**SYDNEY NORTH PLANNING PANEL
COUNCIL ASSESSMENT REPORT**

Panel Reference	PPSSNH-80
Application Number	DA2020/0393
LGA	Northern Beaches
Proposed Development	Demolition of existing structures and construction of a mixed-use development comprising retail uses, gymnasium, commercial car wash, shop-top housing containing 51 dwellings, basement car parking for 193 vehicles spaces, landscaping and a central public square.
Land to be developed (Address)	Lot 1 in DP 1199795, No. 28 Lockwood Avenue, Belrose
Owner	Platinum Property Advisors No 1 Trust
Applicant	Willana Urban
Date of Application	24 April 2020
Number of Submissions	134
Recommendation	Refusal
Regional Development Criteria (Schedule 7 of the SEPP (State and Regional	Development with a Capital Investment Value (CIV) of more than \$30 million
List of all relevant s4.15(1) (a) matters	<ul style="list-style-type: none"> • Environmental Planning and Assessment Act 1979 • Environmental Planning and Assessment Regulations 2000 • State Environmental Planning Policy No. 55 – Remediation of Land and draft SEPP • State Environmental Planning Policy No. 65 – Design Quality of Residential Apartment Development • State Environmental Planning

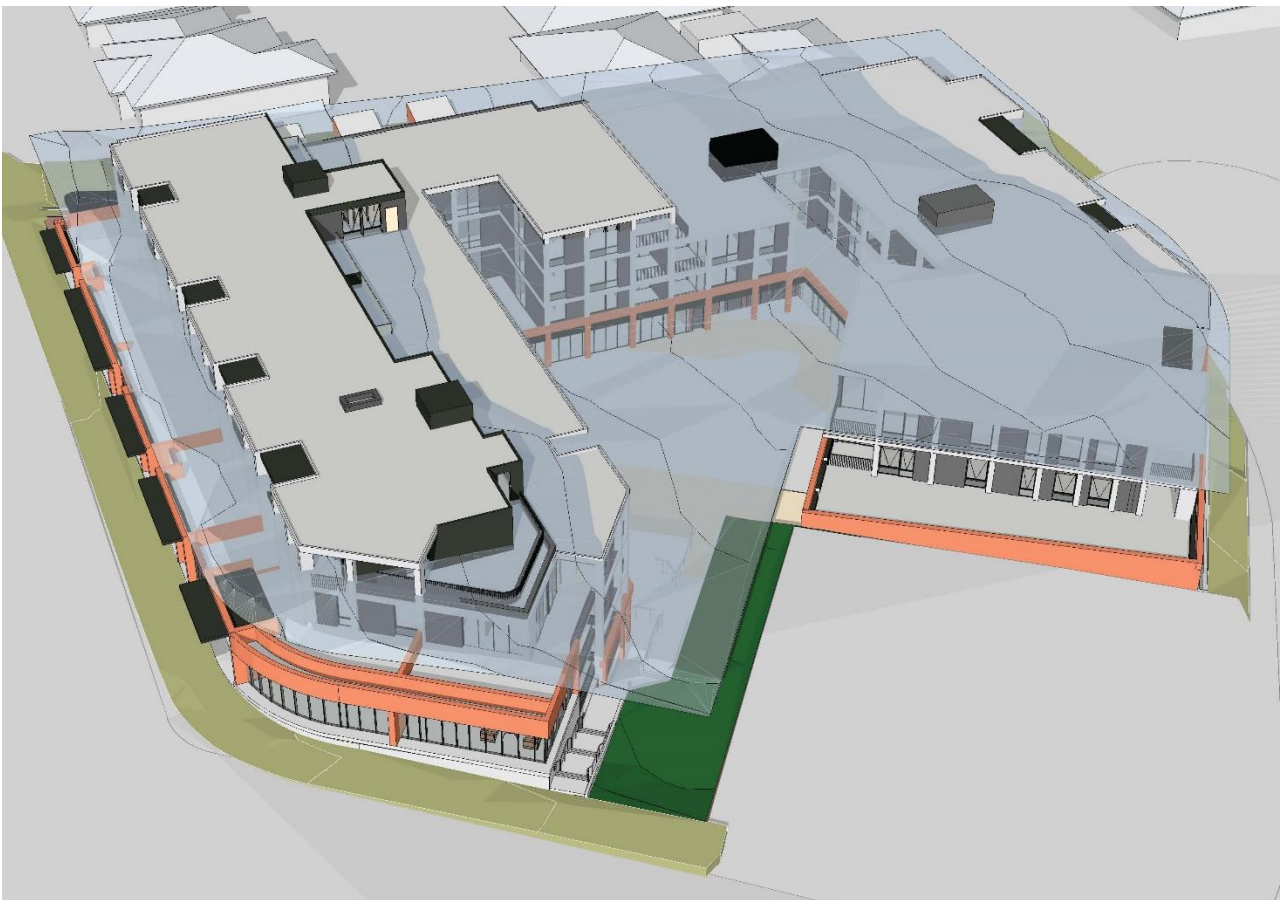
The following 3D height plane diagrams have been submitted by the applicant. Note that these diagrams do not show roof top structures such as balustrades, planter boxes and pergolas:

As can be seen in the above diagrams, the proposed top level on the Lockwood Avenue frontage exceeds the building height control almost entirely. In addition, the majority of the building as it faces Glenrose Place exceeds the building height control by up to 915mm. The west-facing building on the southern portion of the site exceeds the building height control by up to 2.2m (to the top of the planter boxes). The internal facades of the building facing the public square exceed the building height control by up to 2.7m to the top of the balustrade (western side) and 2.0m to the top of the balustrade (northern side). All of the lift overruns exceed the building height control. Three rooftop pergolas exceed the building height control by 3.7m (south-western pergola), 1.7m (north-western pergola) and 2.2m (south-eastern pergola).
